Service Bulletin
No. : MZ07-100
Date: November 7, 2007

Model: SR8200

Subject: Correction of the SCHEMATIC DIAGRAM.

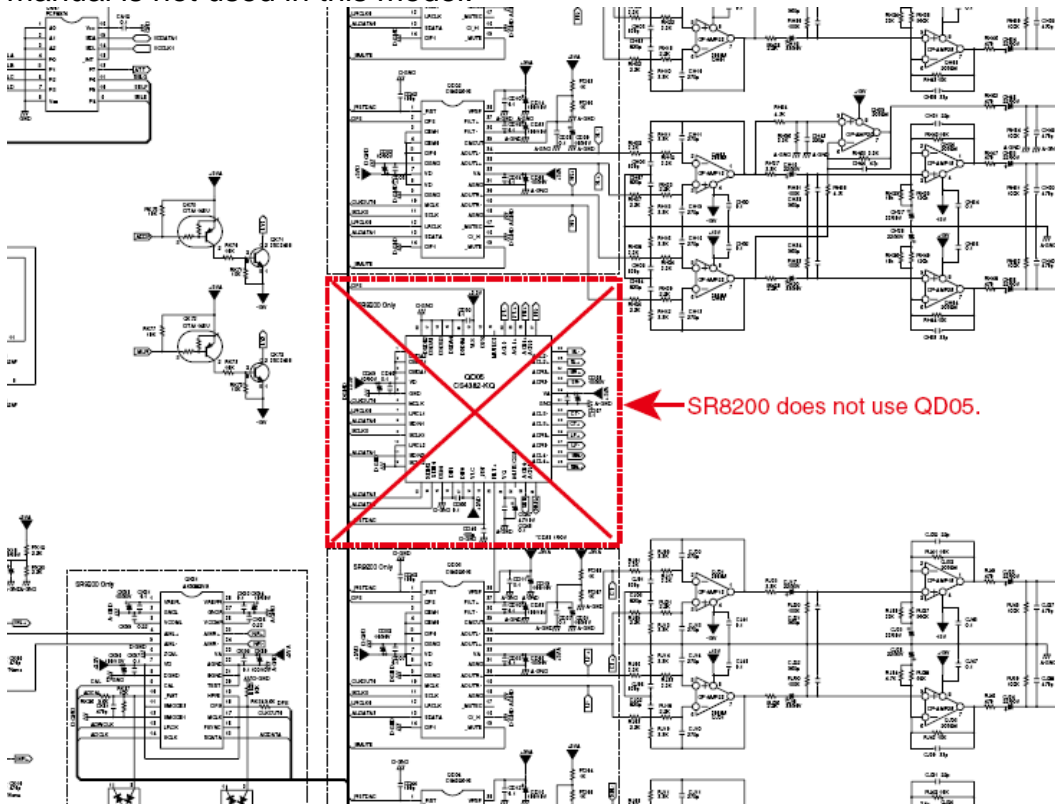
Symptom: The SCHEMATIC DIAGRAM mentioned on the SR8200's Service Manual is not correct. (Service Manual page 43, 44)

Solution: Reference number QD05 shown on page 43, 44 of the service manual is not used in this model.
